HAY ROAD SLUDGE DRYING SITE
CHERRY ISLAND
WILMINGTON, DELAWARE

Schnabel Reference 06150049

DELAWARE DEPARTMENT OF NATURAL RESOURCES AND ENVIRONMENTAL CONTROL

The Delaware Department of Natural Resources and Environmental Control (DNREC) retained Schnabel Engineering North, LLC (Schnabel) to perform an objective and independent third party evaluation of the proposed remedy for the DuPont Hay Road "Iron Rich" Site. The scope of services includes:

FIGURE 1: POTENTIAL GROUNDWATER RECHARGE AREA UPSTREAM OF OUTFALL D-002 AND DOWNSTREAM OF THE IRM PILE (SOUTHEASTERN CORNER OF SITE)

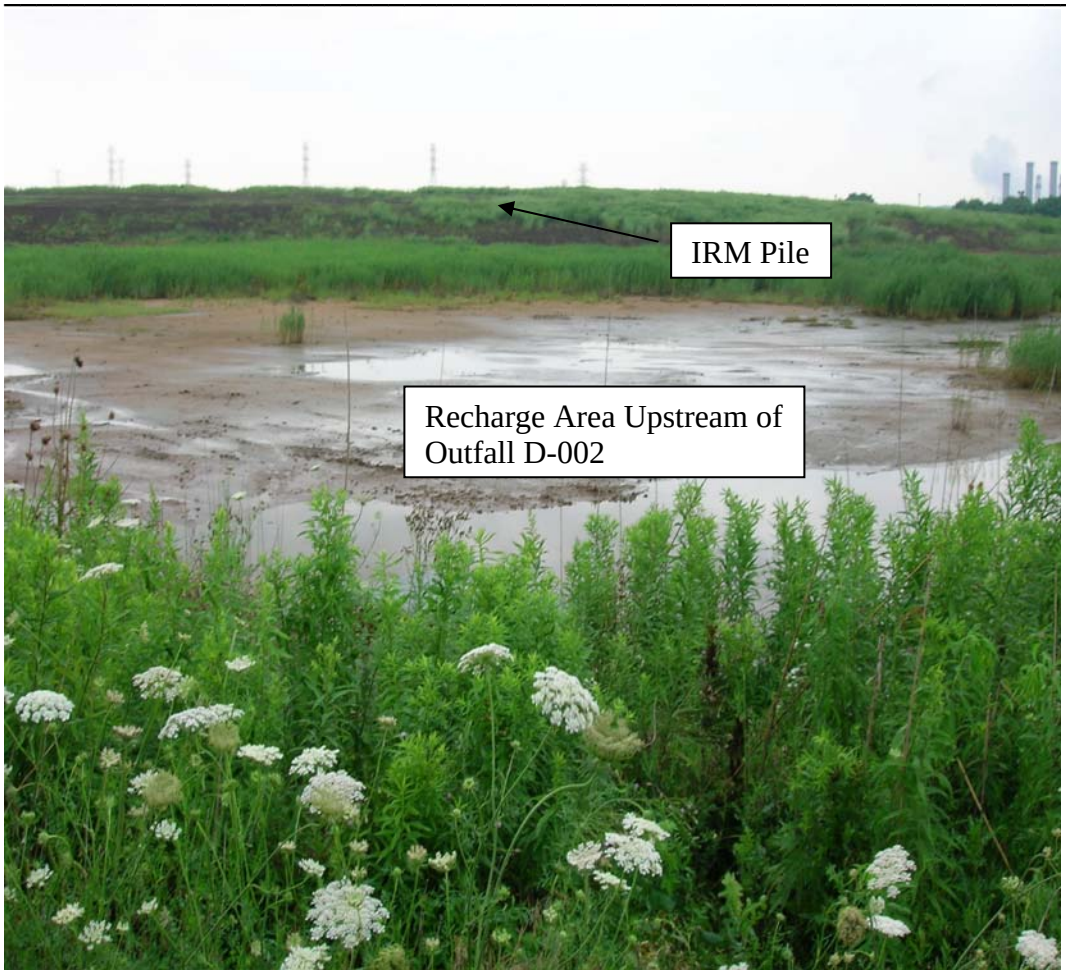
At and around the vicinity of the IRM pile, only three well clusters are monitored at the locations discussed above. Importantly, no monitoring wells or other groundwater data exist for locations underneath the historic or the current footprint of the IRM pile. Additionally, groundwater is not being monitored at the sediment control basin constructed downstream of the IRM pile and upstream of the storm water outfall D-002, located in the southeastern portion of the Site. This sediment control basin was constructed to prevent storm water runoff carrying sediment transport from the IRM into the outfall. The construction of the sediment basin has resulted in the diversion of stormwater runoff from the IRM pile into this basin. Because the Site receives substantial precipitation (~45 inches) year-round, significant storm water appears to collect within this sediment basin, which necessarily contributes to significant vertical infiltration of IRM-impacted water and recharge of shallow groundwater (see Figure 1). At a minimum, a monitoring well to monitor quality of shallow groundwater (within the dredged material) should be considered at this critical location.

FIGURE 3: SIMULATION OF IRON CONCENTRATIONS (MILLIGRAMS PER LITER) FROM EDGE OF IRM PILE TO DELWARE RIVER IN FEET

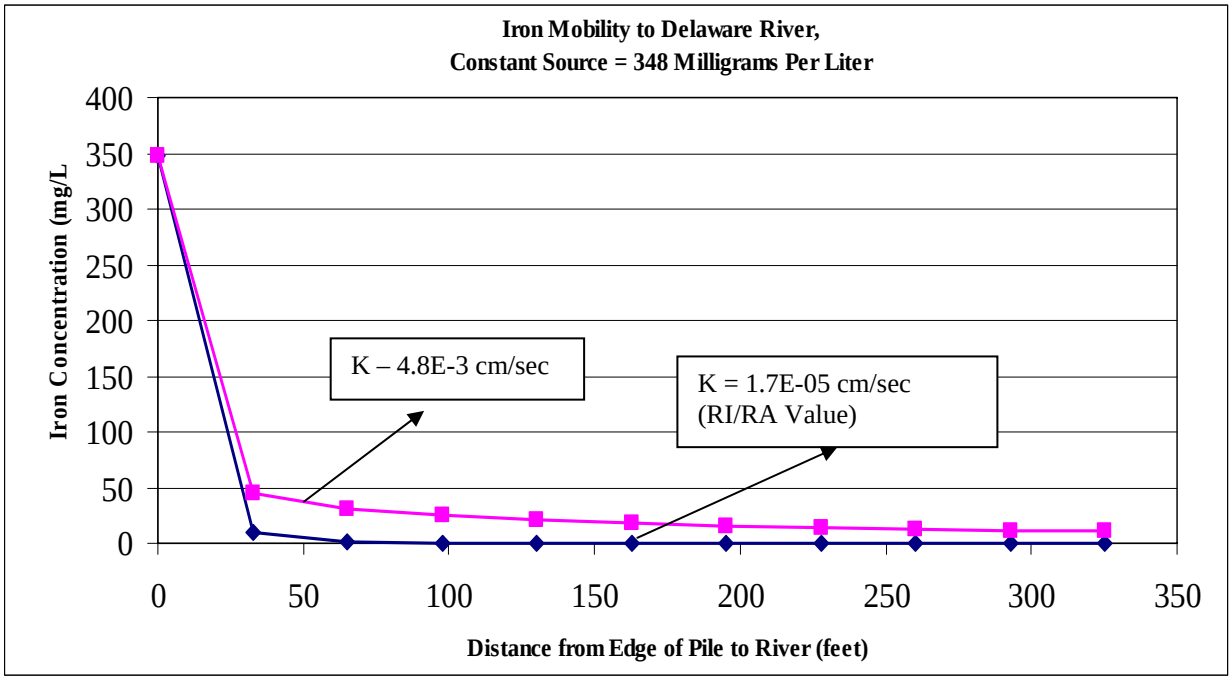
Graphs depicting the attenuation in iron concentration relative to distance from the edge of the IRM pile to the Delaware River (assuming a uniform source concentration of 348 mg/L, after 1,000 years) for two values of hydraulic conductivity (4.8E-03 and 1.7E-05 cm/sec) are presented in Figure 3.
